Memo

To: David Powlen
From: Jeff Walton, Associate Planner; 910-341-3260
CC: File;
Date: 3/4/2016
Re: Lidl Grocer

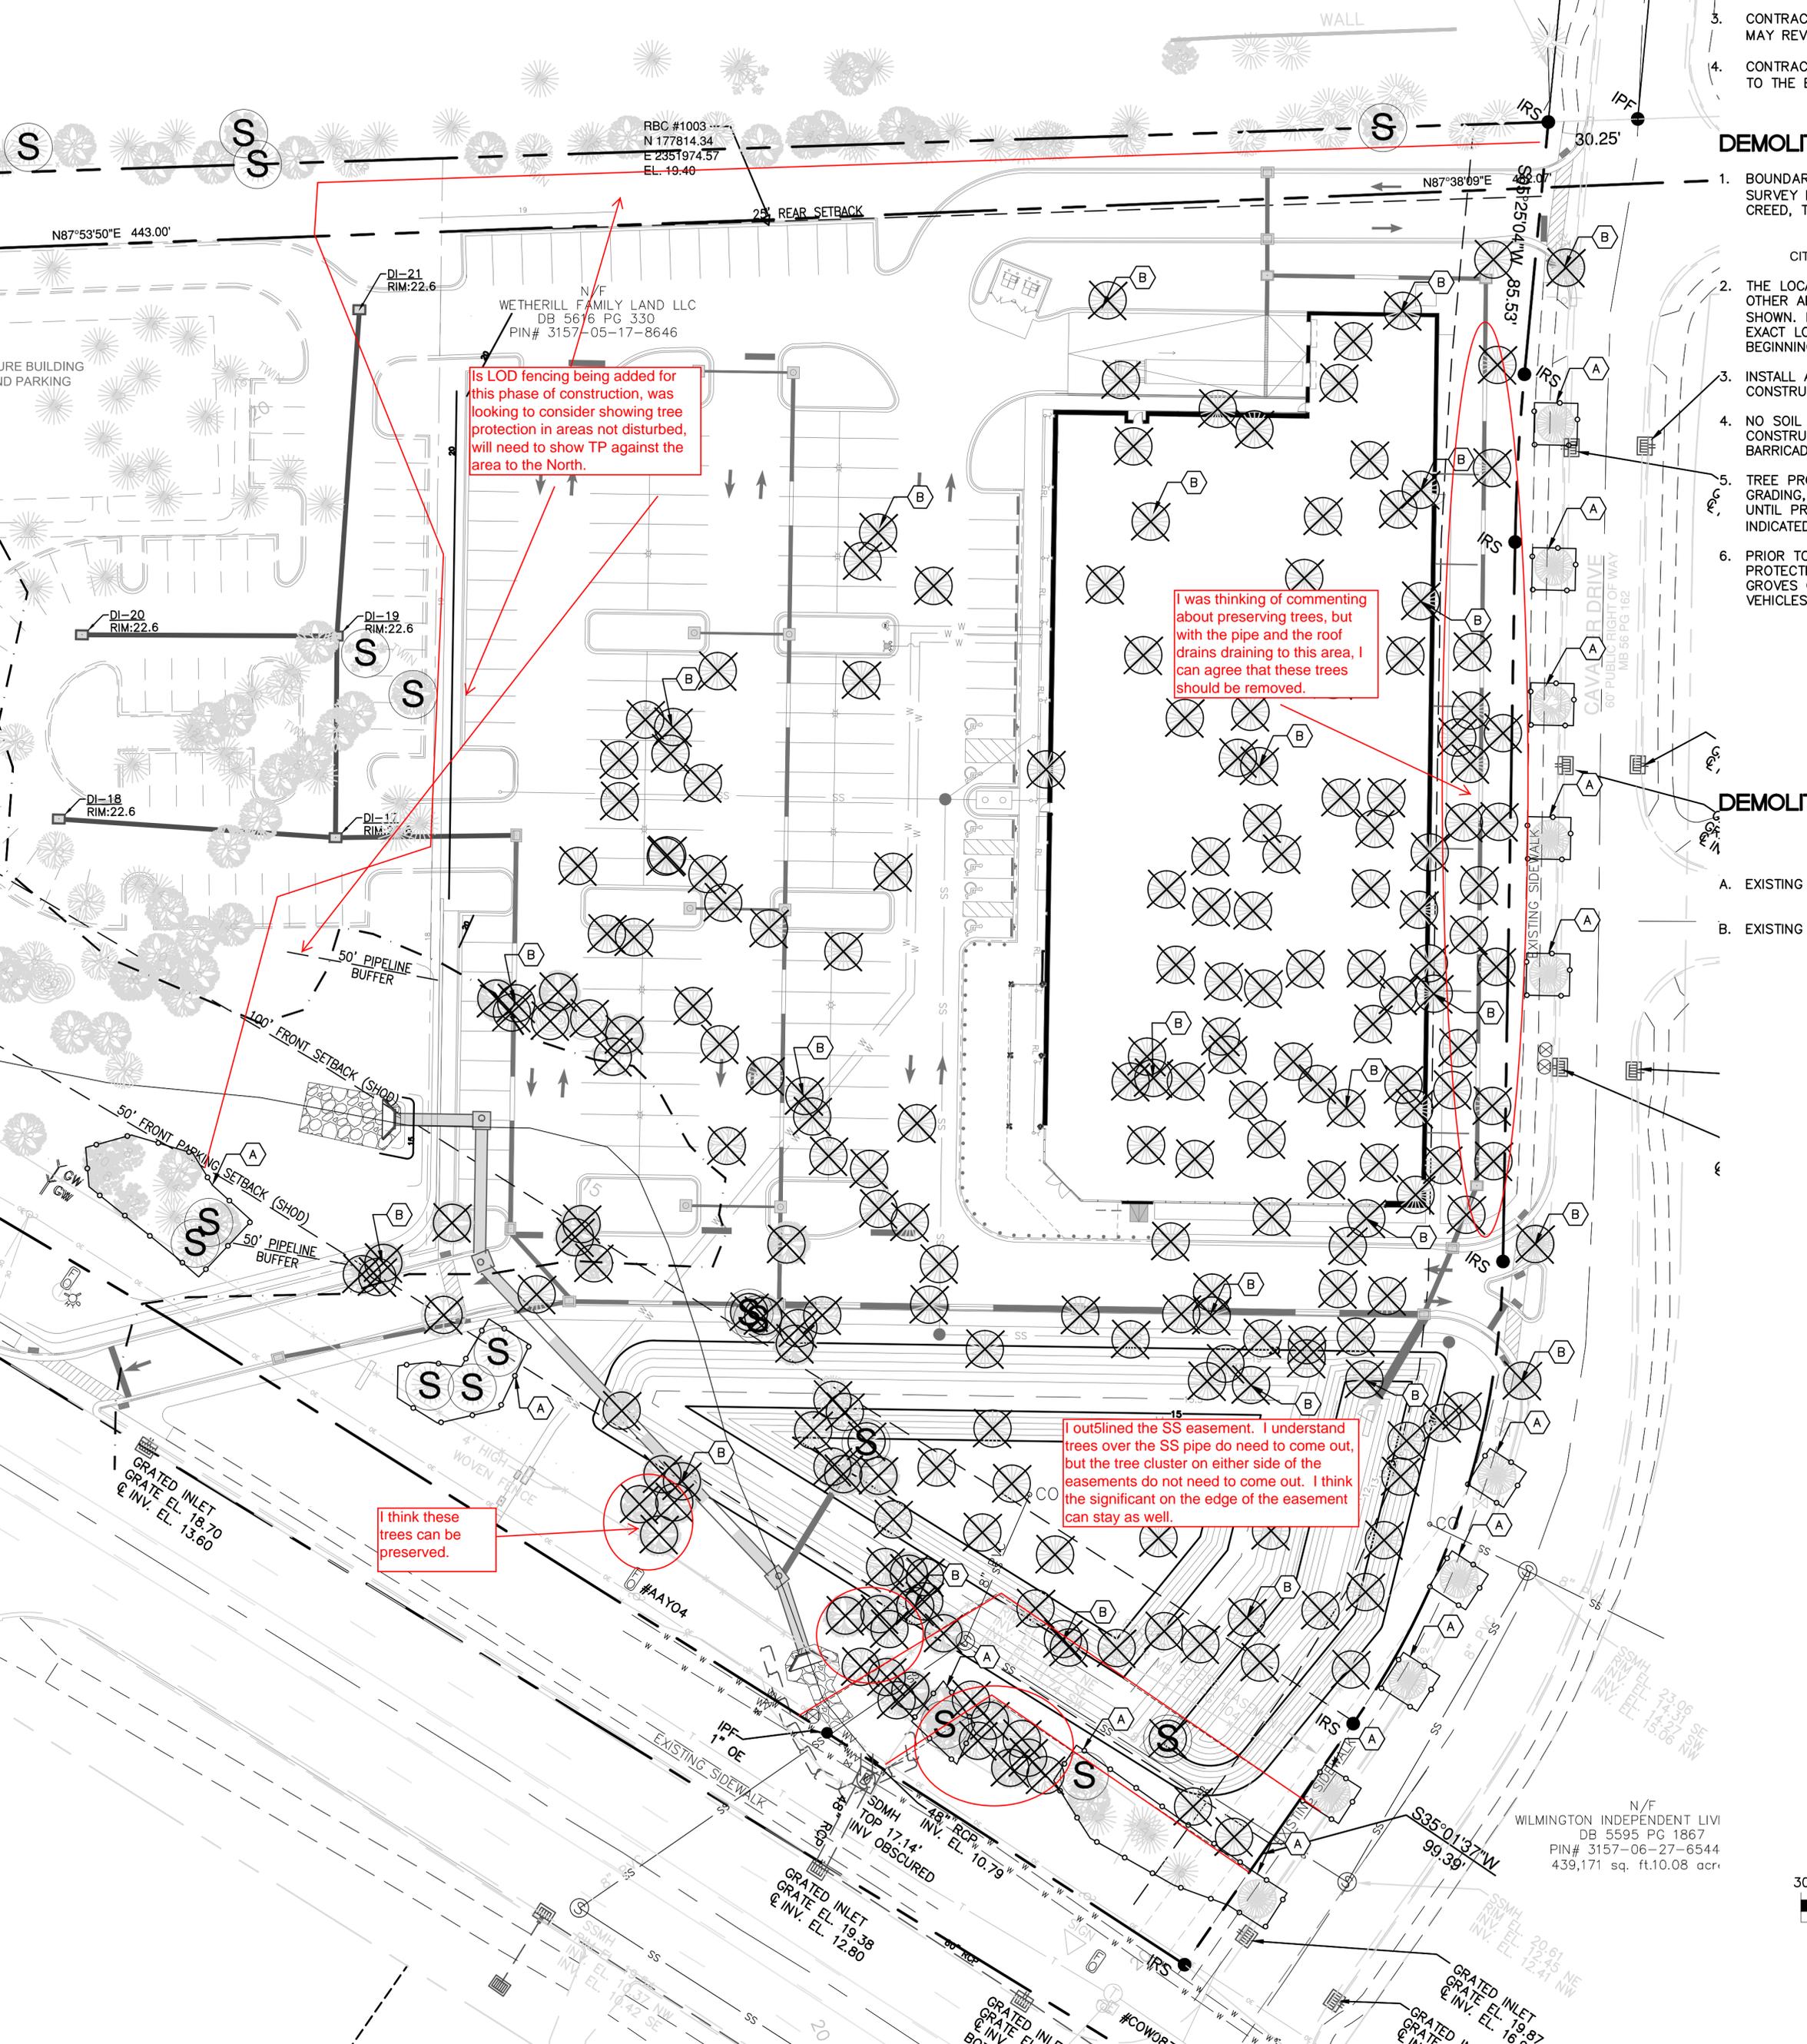
Is LOD fencing being added for this phase of construction, was looking to consider showing tree protection in areas not disturbed, will need to show TP against the area to the North.

I was thinking of commenting about preserving trees, but with the pipe and the roof drains draining to this area, I can agree that these trees should be removed.

I outlined the SS easement. I understand trees over the SS pipe do need to come out, but the tree cluster on either side of the easements do not need to come out. I think the significant on the edge of the easement can stay as well.

I think these trees can be preserved.

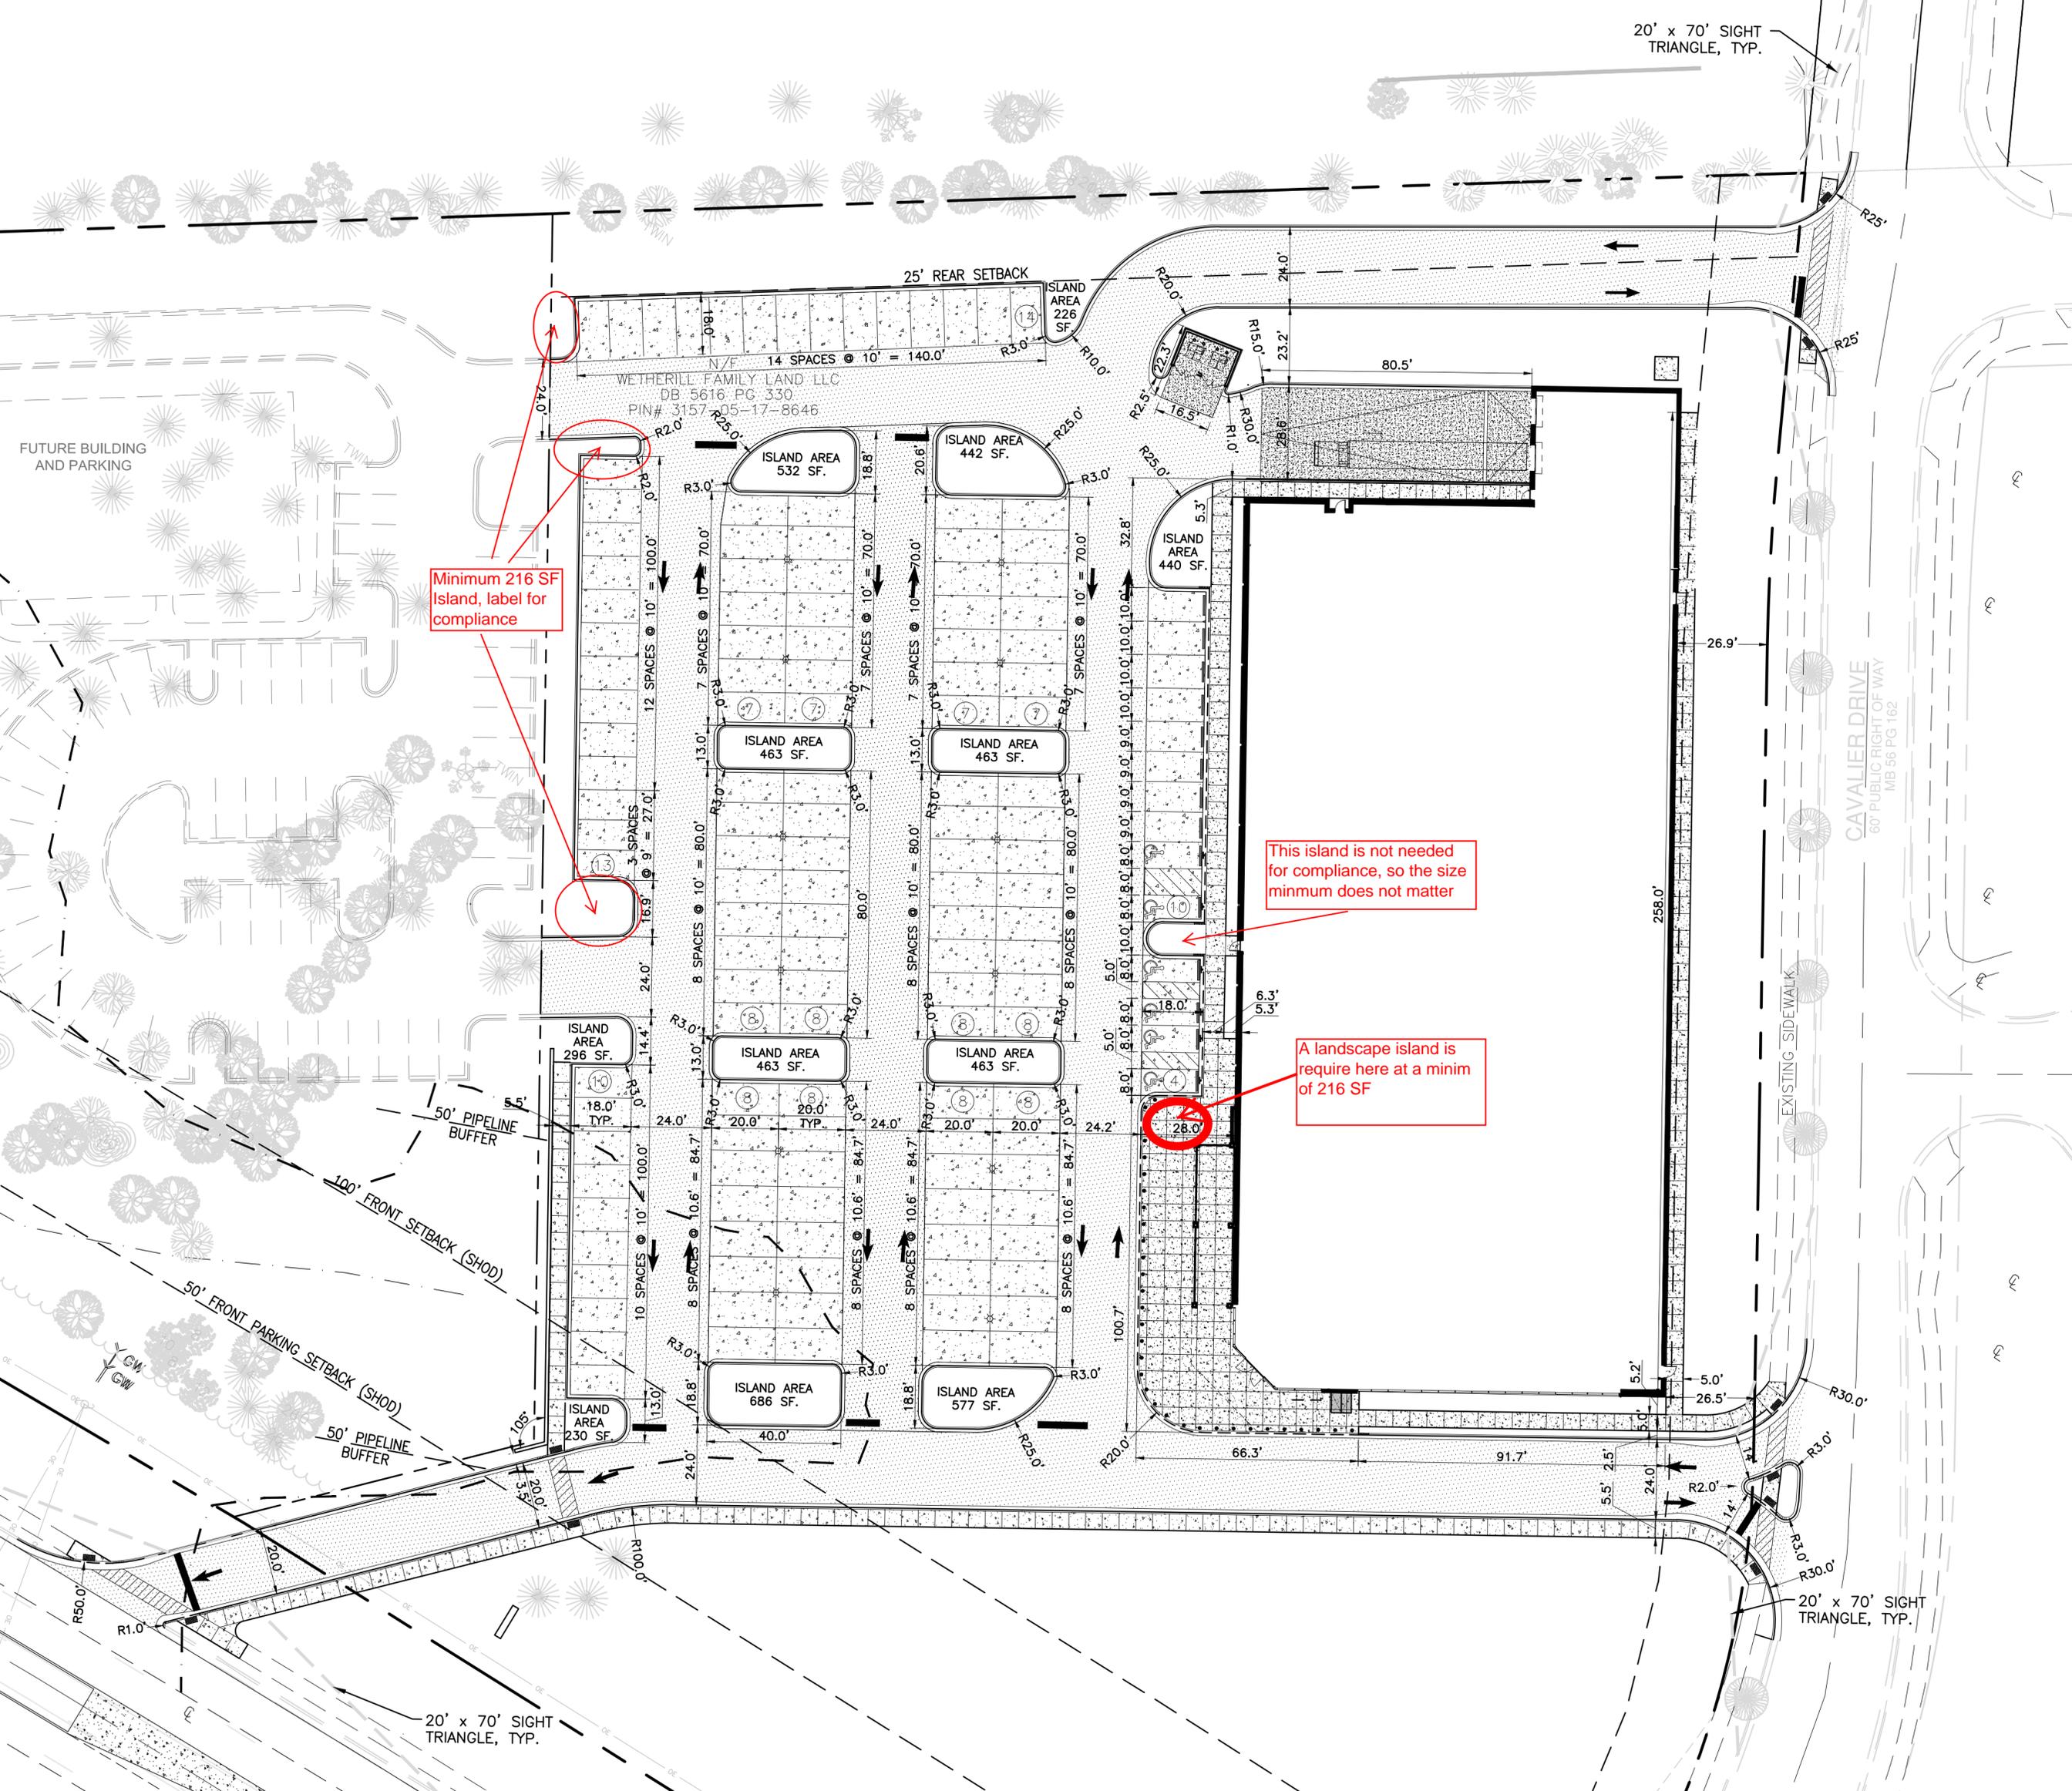
Minimum 216 SF Island, label for compliance

This island is not needed for compliance, so the size minimum does not matter

A landscape island is require here at a minim of 216 SF
